Relief Request: S1-RR-B01
Second Ten-Year Interval Inservice Inspection NDE Exam Limitations
Salem Unit 1

Attachment I

Salem Unit 1 NDE exam limitations of Class 1 bolting components and welds located upon pressure vessels and piping systems

Summary # 00440
1-RPV-6046B
Dollar plate weld
Closure Head

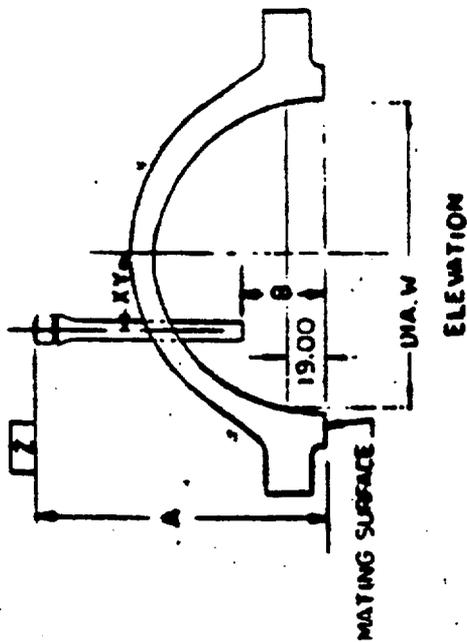
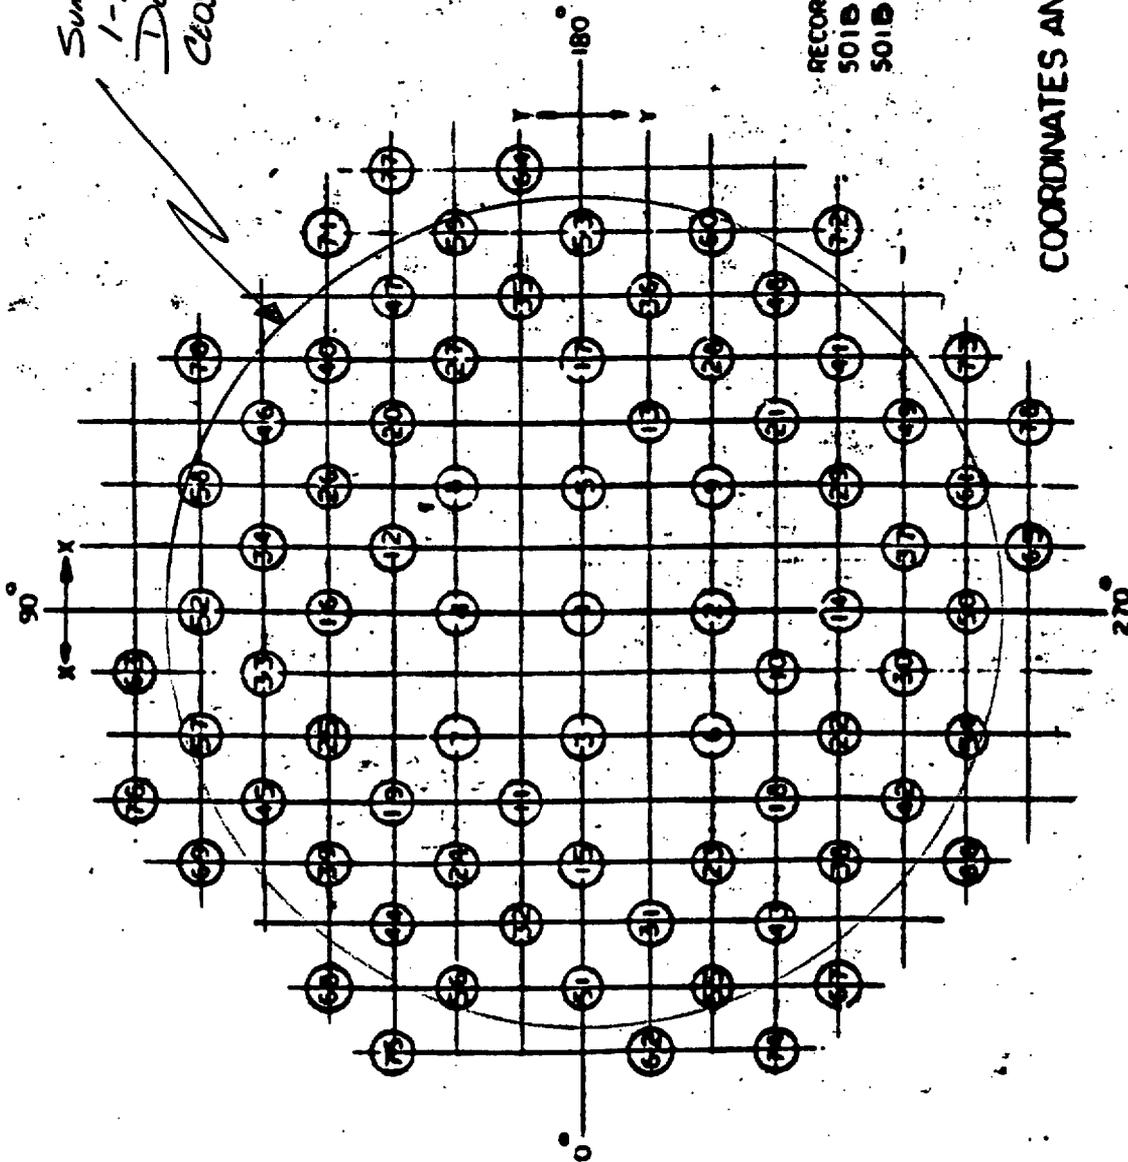
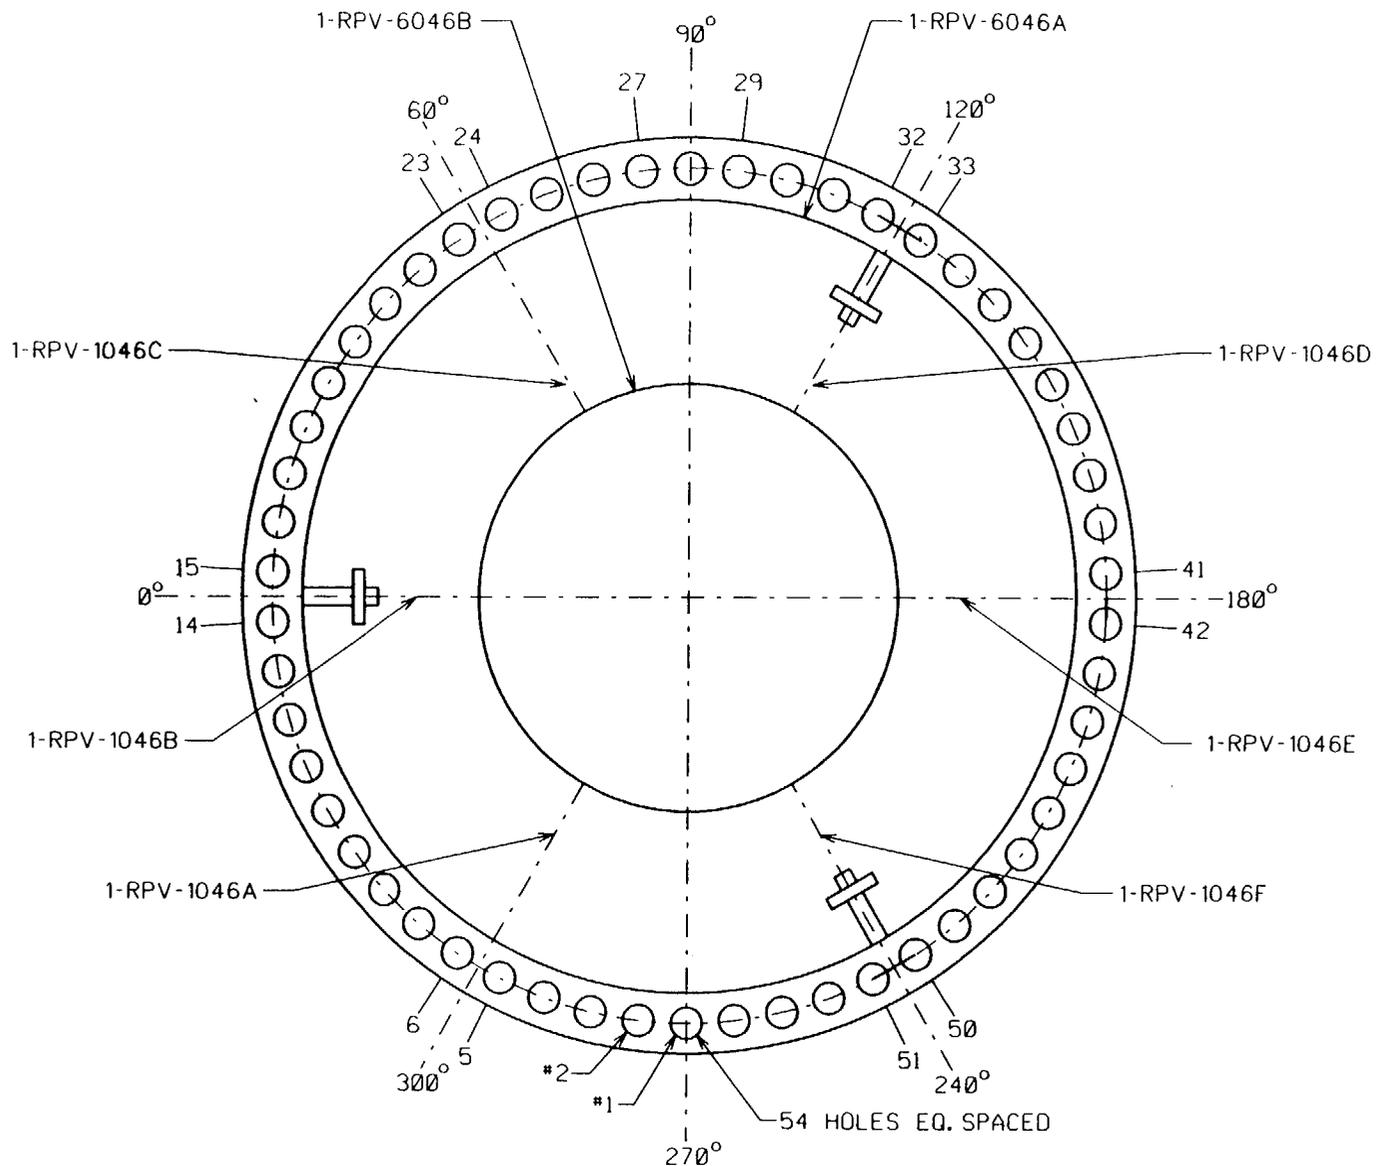
004400	2-3-2	14	4/23/01	RPV	1-RPV-6046B	Dollar Plate Closure Weld	B-A	B1.21	1	UT	40% [Note: Due to personnel exposure concerns coverage was estimated.]	IWB-2500-3	This UT exam was performed in April 2001 using approved PDI exam techniques. A 60-degree Refracted Longitudinal (RL) UT Exam was performed with no recordable indications noted. The head's shroud was raised to achieve maximum access to the weld. The examination was performed above and below the weld axially and circumferentially in the accessible areas between the CRD penetrations. Due to the dose rates on the head being in excess of 1R/hr, precise measurement of the weld length examined was not possible. Therefore, only an estimation of the coverage was provided. The total estimated code coverage achieved was 40%. There have been no problems identified to date associated with Salem Unit 2 reactor pressure vessel closure head. A VT2 examination for the detection of boric acid deposits during 1R14 (May 2001) did not identify any signs of leakage or loss of structural integrity within this area. System leakage tests (VT2) are conducted at the conclusion of each outage to detect presence of leakage. No leakage has been noted in this area of the weld.	No

SKETCH #4
293

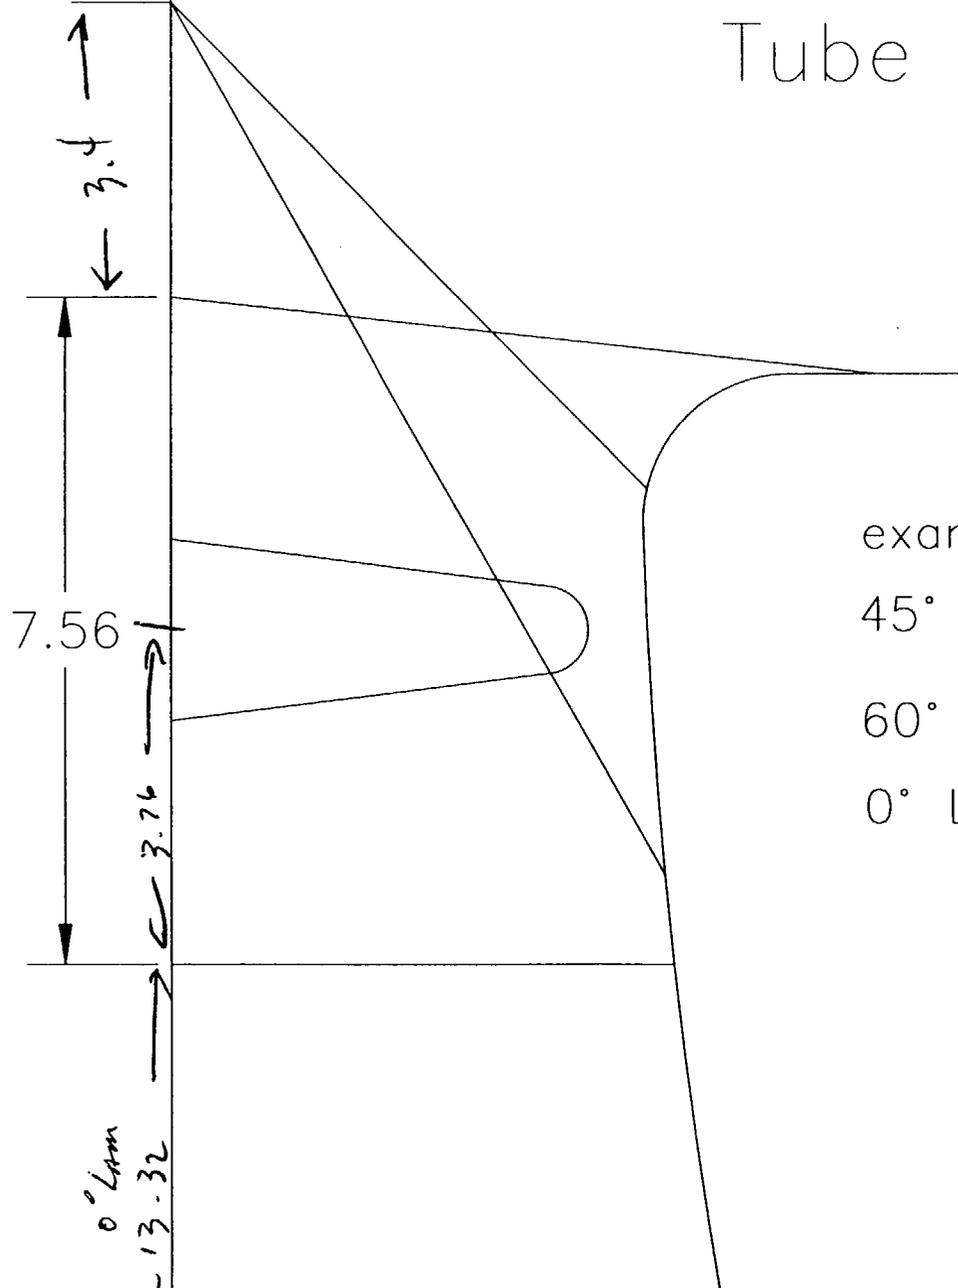
UT thickness
5.5"

exam vol = 42.04sq"
45° limited = 2.75sq"
60° limited = 11.37sq"
0° Lam' and DAC no limitation

Sketch # 8595

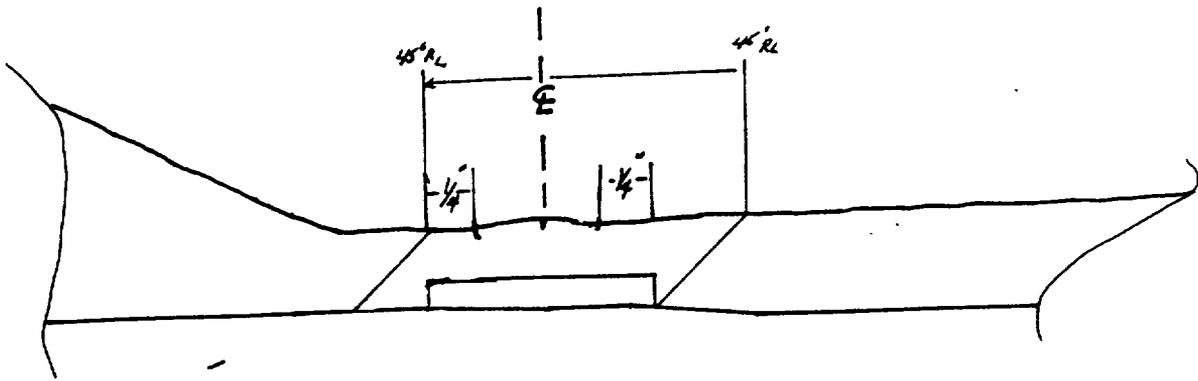
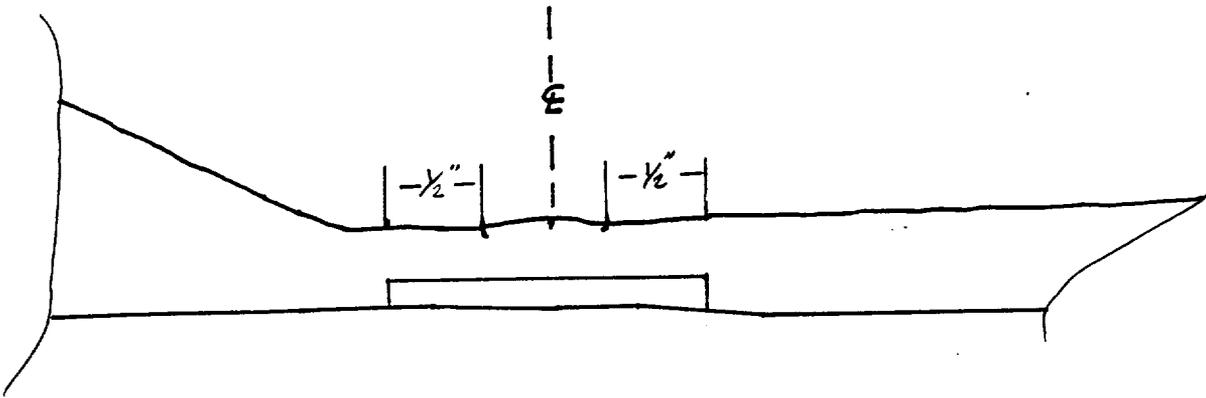
AXIAL SCANS
NO LIMITATIONS UPSTREAM ONLY
50% LIMITATION DOWNSTREAM

Sketch # 13
181

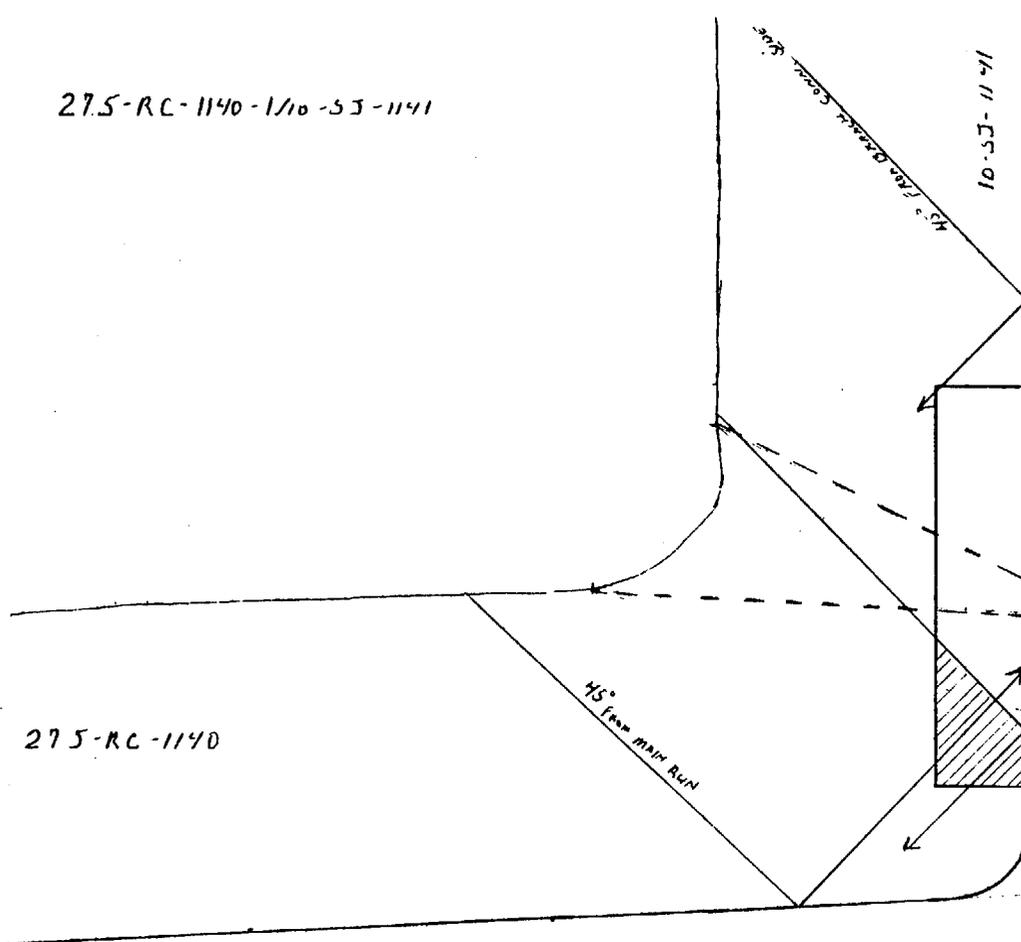
TOTAL VOLUME OF EXAM - 107.49
 TOTAL VOLUME OF LIMITATION - 26.45
 ONE-DIRECTIONAL COVERAGE - 100%
 TWO-DIRECTIONAL COVERAGE - 75.4%

Sketch 19
11 of 13

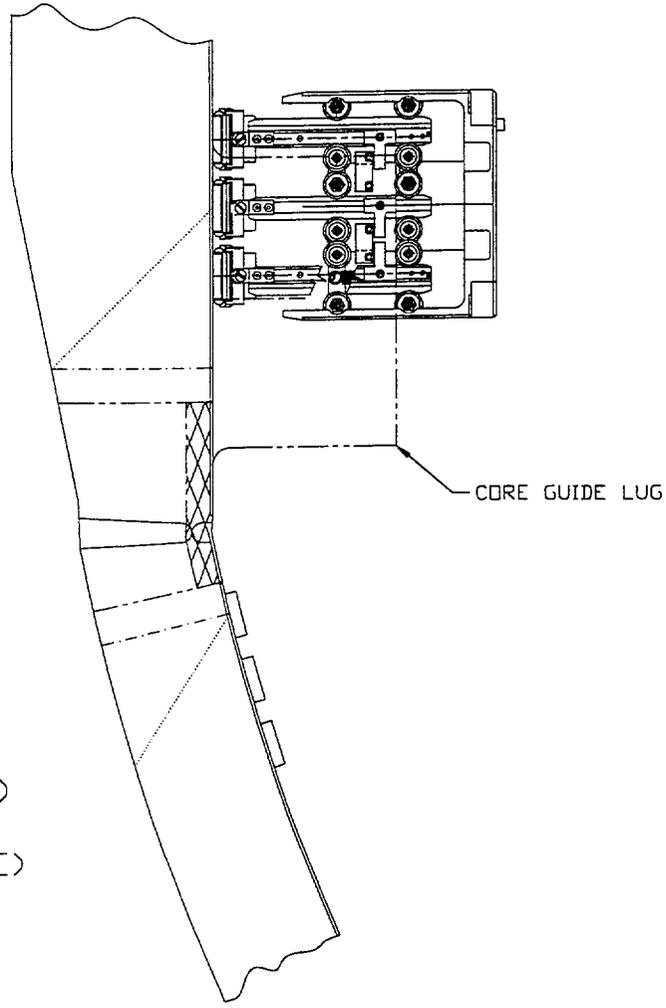
W13
70°
WELD AREA (NEAR SURFACE)
=0.88 SQ IN.
BASE METAL (NEAR SURFACE)
=7.86 SQ IN.

NOTE: UNDER LUGS WAS NOT SCANNED DUE TO STAINLESS STEEL INSERTS NOT SHOWN ON CUSTOMER DRAWINGS SUPPLIED TO FTI-ANP.
